**CITY OF OLYMPIA  
DESIGN REVIEW BOARD**

**COMBINED CONCEPTUAL & DETAIL DESIGN REVIEW STAFF REPORT  
June 13, 2024**

<b>Project Name/Number:</b>	Legion & Jefferson, 24-1901
<b>Applicant:</b>	Thomas Architecture Studios
<b>Location:</b>	411 Legion Way SE
<b>Project Description:</b>	5-story mixed use apartment building with 87 residential units over 1 story of retail and parking.
<b>Zoning District:</b>	Downtown Business (DB)
<b>Design District:</b>	Downtown
<b>Comprehensive Plan Designations:</b>	Central Business District with High Density Neighborhood Overlay
<b>City Staff:</b>	Casey Mauck, Assistant Planner Phone: 360.753.8048 E-mail: cmauck@ci.olympia.wa.us
<b>Public Notification:</b>	In accordance with OMC 18.70, notice of the application, neighborhood meeting, and Design Review Board meeting was posted on the site and mailed to adjacent property owners on April 11, 2024.

Figure 1. Southern façade of the building with areas highlighted for Board review. Staff suggests requiring brick in the red area and additional blank wall treatment in the yellow area.

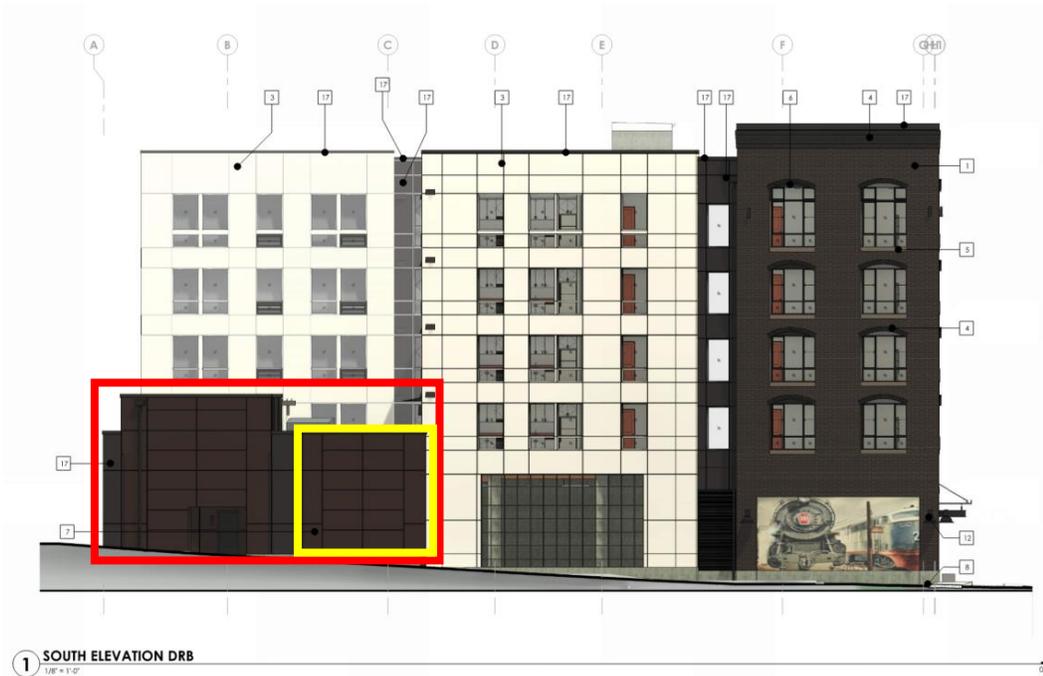
*Blank walls (OMC 18.120.480.B.1):* Blank walls of 400 square feet or larger, without a window, door, or building modulation or other architectural feature that face a public street, are prohibited unless treated. The southern façade includes a blank wall along the lower half of the building that is currently proposed to be surfaced with Hardieplank panels in the color “Fairfax Brown” (see yellow box in Figure 1 below). While the panels do add visual interest at a pedestrian scale, it does not use a variety of surfaces. Staff suggest requiring that part of this façade, east of the exterior door, has additional elements to treat blank walls such as a grate with irrigated vegetation or artwork. This condition could be assessed at the time of building permit by staff.

**Multiple sided buildings (OMC 18.120.440.B.9):** Multiple sided buildings must have consistent visual identity from all sides visible to the general public, except building walls adjacent to alleys and walls immediately abutting neighboring properties. A building must have a comparable level of quality of materials, detailing, color schemes, and fenestration on all sides visible to the general public. This requirement applies to all façades except for the west, which abuts neighboring properties. The south façade uses fiber cement siding on the western two-thirds of the building, while the other façades use brick in darker areas. Staff suggest requiring that brick is used in the area currently proposed to be Hardieplank in the color “Fairfax Brown” (see area in figure 1 below), excluding the portion covered by blank wall treatments. This condition could be assessed at the time of building permit by staff.

1. The blank wall on the southern façade, currently proposed to be Hardieplank in the color “Fairfax Brown” east of the exterior door, must include additional blank wall treatments pursuant to OMC 18.120.480.B.1 such as a grate with irrigated vegetation or artwork. This condition will be assessed at the time of building permit by staff.

2. Areas currently proposed to be Hardieplank in the color “Fairfax Brown” on the southern façade must be replaced with brick, excluding areas with additional blank wall treatment. This condition will be assessed at the time of building permit by staff.
